ERRATA TO FINAL EIR
OVERNIGHT SOLAR PROJECT
STATE CLEARINGHOUSE NO. 2024010434

ERRATA TO THE FINAL EIR

San Bernardino County (County), as the Lead Agency under the California Environmental Quality Act (CEQA), has prepared this Errata to clarify and correct information in the Final Environmental Impact Report (Final EIR) for the Overnight Solar Facility Project (PROJ-2023-00087; proposed project), State Clearinghouse (SCH) No. 2024010434. This document, in conjunction with the Final EIR, published on May 19, 2025, and the Draft EIR, published on October 2, 2024, comprises the Final EIR for the project.

Figure 3.3-5. Burrowing Owl Survey Results

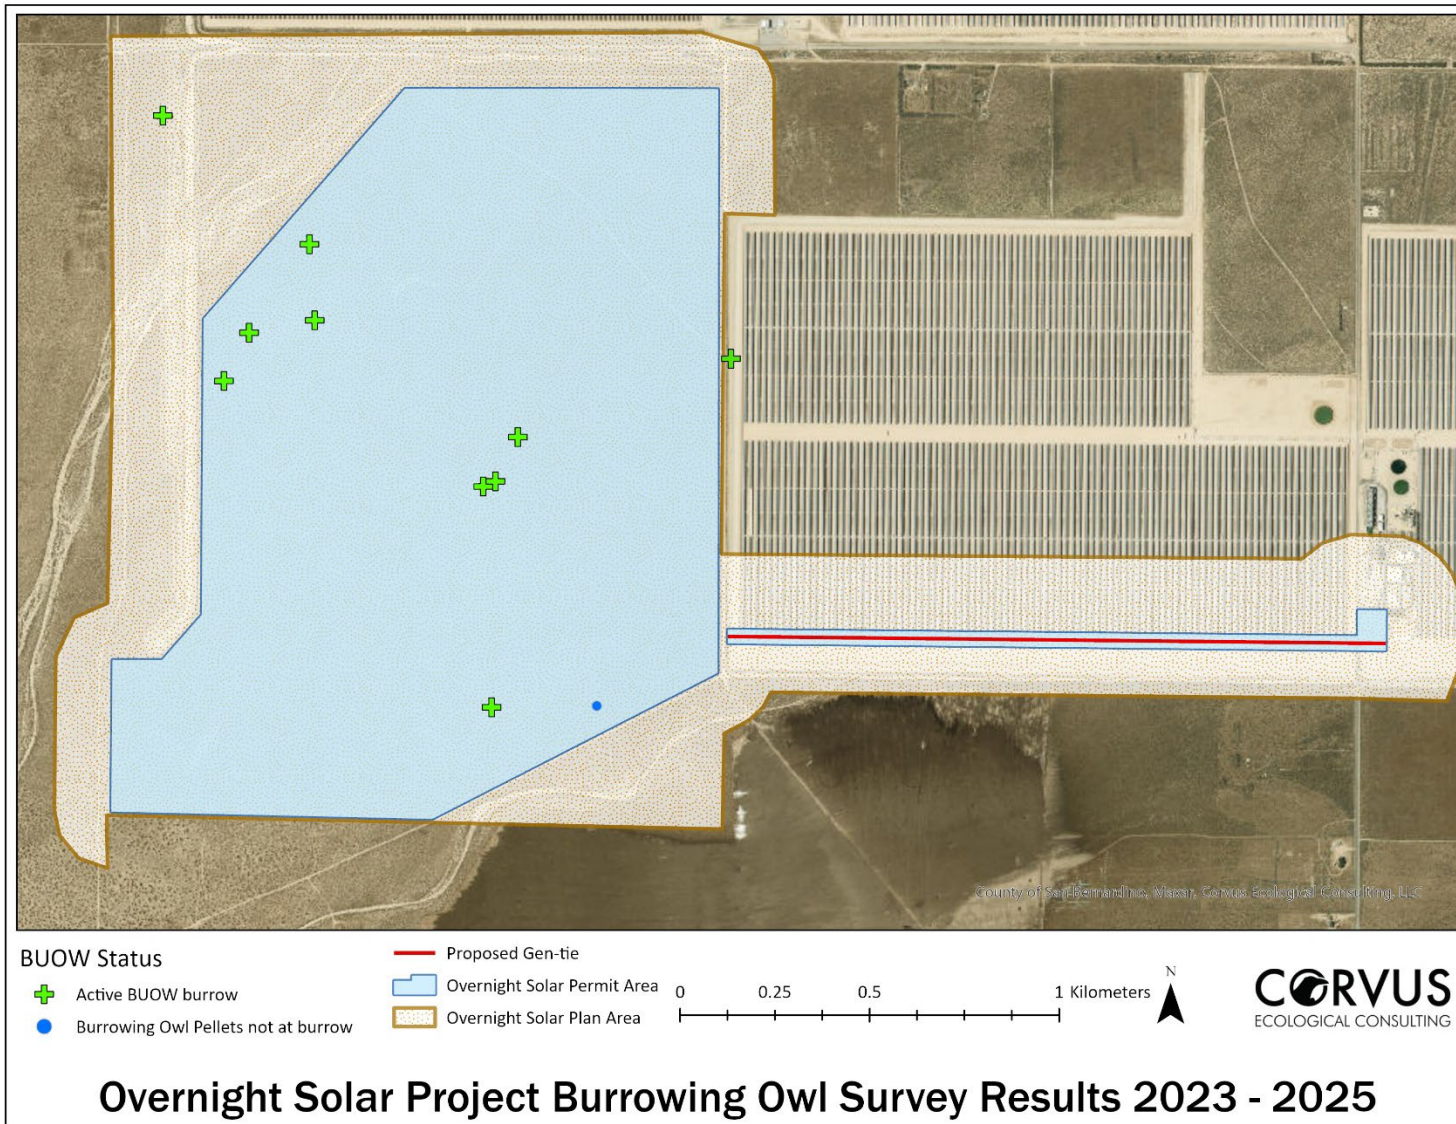
Final EIR Location	Final EIR Page #	Summary of Revision
Section 3, Minor Revisions to the Draft EIR		
3.3 Biological Resources		
Draft EIR Page 3.3-12	Page 3-5 and 3-6; Figure 3.3-5	Delete reference to “historic” burrowing owl signs. Delete “historic” designation symbolized by red triangle.
Draft EIR Page 3.3-26 through 3.3-27	Pages 3-8 through 3-10	Mitigation Measure BIO-4. Clarify that off-road travel shall be prohibited in all native habitats adjacent to the project during all phases of the project. Any off-road travel outside the project site would need CDFW review and approval.
Draft EIR Page 3.3-27	Page 3-10	Mitigation Measure BIO-5. Add mitigation ratio; delete reference to mitigation to be determined in the ITP.

Initial burrowing owl surveys were conducted during peak breeding season in 2023 (April 15 to July 15), with two biologists walking 10-meter belt transects across the original survey area. Biologists examined natural and artificial substrates for occupation by Western Burrowing Owl, and recorded signs of use (i.e., feathers, pellets, burrows, whitewash, egg fragments, live animals/breeding pairs, and live birds). Biologists marked all occupied and suitable burrowing owl burrows during this effort. During May 2023, April 2024, and March 2025, all suitable Western Burrowing Owl burrows were revisited in an effort to determine occupancy and site use. Additional Western Burrowing Owl focused surveys were performed in May, June, and July 2024, within the current project site and a 150-meter buffer. The proposed gen-tie corridor was surveyed for burrowing owl on March 26, 2025. Signs of burrowing owl use were considered "historic" if detected within 2023 or 2024 and "active" if detected within 2025. Three historic signs and five active signs of burrowing owl use have been observed within the current project footprint, one active sign of burrowing owl use has been observed northwest of the project footprint, and one active sign of burrowing owl use has been observed within

the Mojave Solar Facility (**Figure 3.3-5**). The occupied burrowing owl burrow within the 150-meter buffer of the current project footprint within the existing Mojave Solar Facility, was detected more than 875 meters from the proposed project gen-tie located in the facility (**Figure 3.3-5**). However, no signs of burrowing owl use were observed along the proposed gen-tie corridor within Mojave Solar Facility during the 2025 surveys. For these reasons, Western Burrowing Owl is determined to be present within and around the project footprint.
